Subject: N202295800 - Service Update
Exhaust Cam Position Sensor Fault

Models: 2020 Chevrolet Malibu equipped with 1.5L DOHC Turbo Engine
(RPO LFV)

N202295800 Exhaust Cam Position Sensor Fault

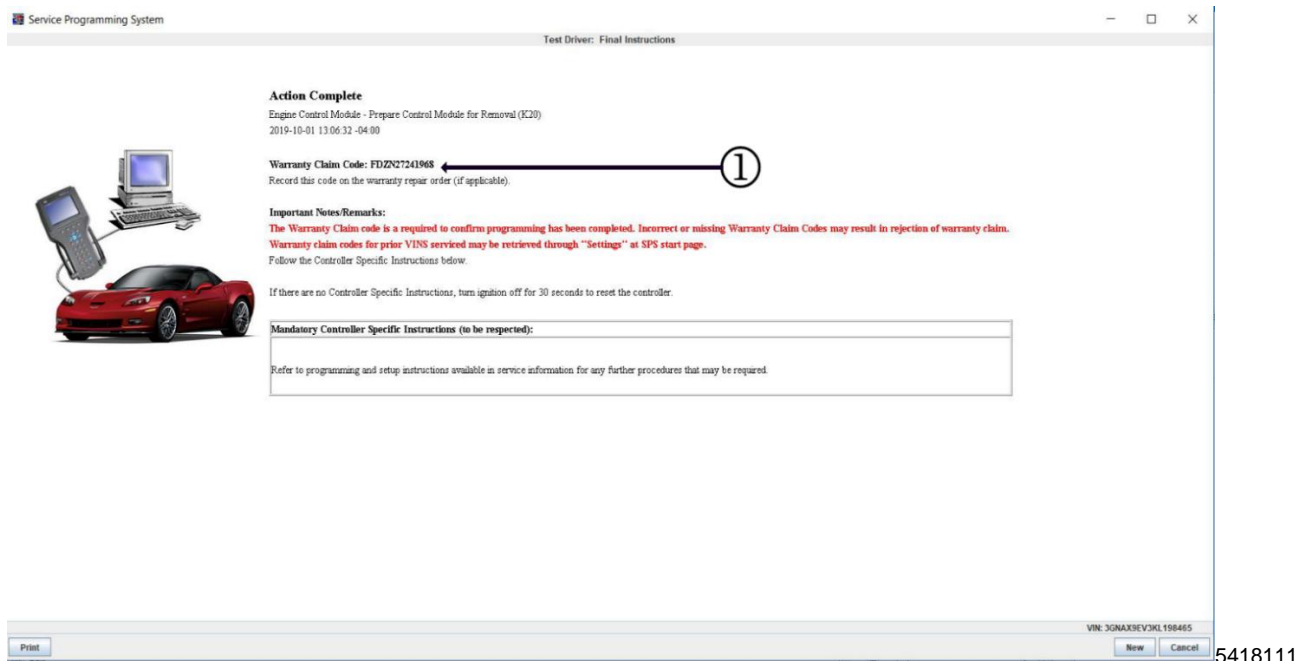
Note: To avoid warranty transaction rejections, you **MUST** record the warranty claim code provided on the SPS Warranty Claim Code (WCC) screen on the job card. Refer to callout 1 for the location of the WCC on the SPS screen.

1. Reprogram the Engine Control Module. Refer to *K20 Engine Control Module: Programming and Setup* in SI.

2. Record SPS Warranty Claim Code on job card for warranty transaction submission.
